Access Compliance Report

(Curb Ramps)

Intersection ID: 19746	Main Street: PINEBURR_RD	Cross Street: THERMAL_RD	Location:	E
ADA ID: 3613F9A6BE3A	Ramp Type: PerpDiag	Initial Pass/Fail: Fail	Overall Compliance: No	Severity Score: 22.5
Codes/Mitigation Info/Possible Solution		Field Measurements/Component Compliance

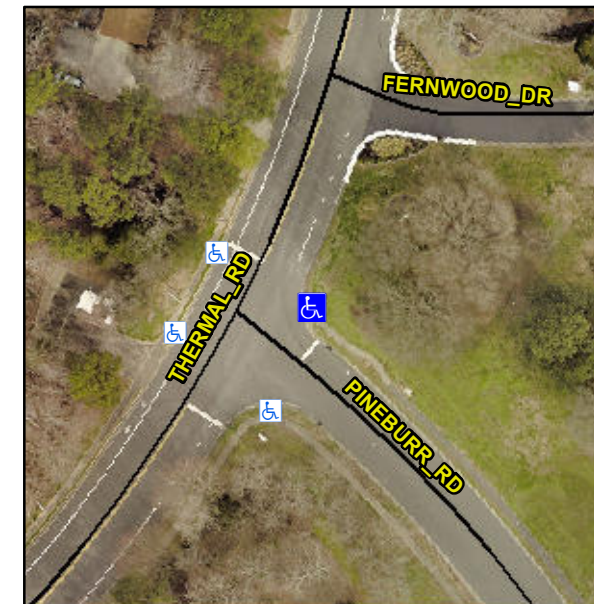
R304.5.1, R304.2.2, R304.5.3

Compliance	Description	Data	Compliance	Description	Data
N/A	Ramp Length (in)	32.0	No	Ramp Slope (%)	9.1
No	Ramp Width (in)	44.0	No	Ramp XSlope (%)	3.9
N/A	Flare Type LT	N/A	N/A	Flare Type RT	N/A
N/A	Flare Slope LT (%)	N/A	N/A	Flare Slope RT (%)	N/A
N/A	Flare Traversable LT?	N/A	N/A	Flare Traversable RT?	N/A
N/A	Landing Length (in)	N/A	N/A	DWS Provided?	N/A
N/A	Landing Width (in)	N/A	N/A	DWS Contrast?	N/A
N/A	Landing Slope (%)	N/A	N/A	DWS Length (in)	N/A
N/A	Landing X Slope (%)	N/A	N/A	DWS Full Width?	N/A
N/A	Landing Curb? (Y/N)	N/A	N/A	DWS Offset (in)	N/A
N/A	Shared Landing?	N/A			
N/A	Gutter Ponding?	N/A	N/A	Gutter Slope (%)	N/A
N/A	Gutter Lip Ht (in)	N/A	N/A	Gutter X Slope (%)	N/A
N/A	Painted X Walk1?	No	N/A	Painted X Walk2?	No
	X Walk 1 Direction	To NW		X Walk 2 Direction	To SW
N/A	X Walk 1 Width (in)	N/A	N/A	X Walk 2 Width (in)	N/A
	X Walk 1 Slope (%)	0.4		X Walk 2 Slope (%)	1.8
	X Walk 1 X Slope (%)	1.4		X Walk 2 X Slope (%)	0.6

Remove & Replace Curb Ramp With Two New Directional Ramps or Equivalent.
